Modification/Change Order No.1
Fort Bend County Drainage District
Oyster Creek Phase III Channel Bank Stabilization
Fort Bend County, Texas
July 31, 2023
Contract No: PO 226815

DESCRIPTION OF MODIFICATION/CHANGE ORDER

PLAN VIEW - SITE 411 & 412
 BANK STABILIZATION - PHASE II
 OSTER CREEK
 IN
 FORT BEND COUNTY, TEXAS

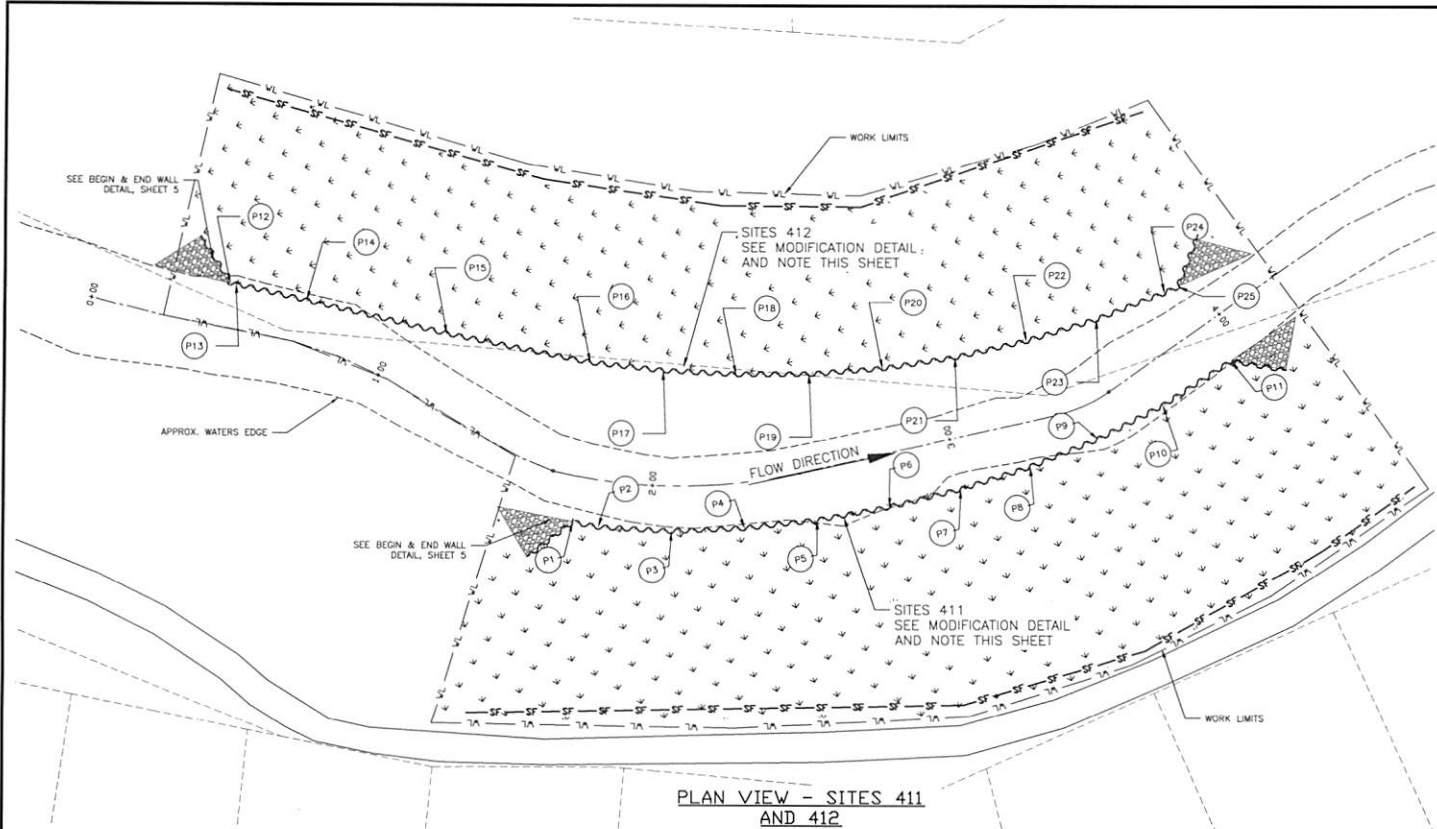
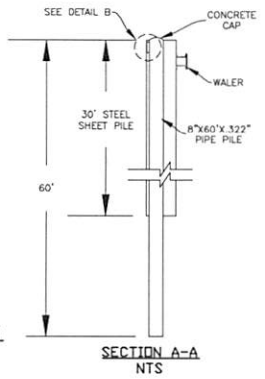
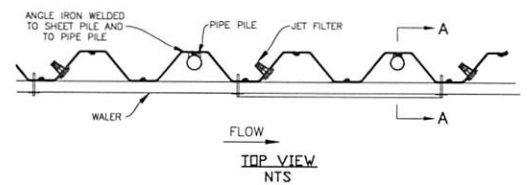
Site 411 and 412 shall be modified as shown on the attached drawings. The 8” pipe pile shall be 60’ in length and driven to depth. The installation and material requirements shall be accordance CS 13 Piling. Pile piles shall be capped with a welded steel plate or concrete shaped to a dome.

MODIFICATION NOTE SITE 411 AND 412:
 CONTRACTOR SHALL INSTALL EVERY OTHER PAIR OF STEEL PILING APPROX 9' INSTALL 8" STEEL PIPE 60" DEEP. SEE DETAILS THIS SHEET.
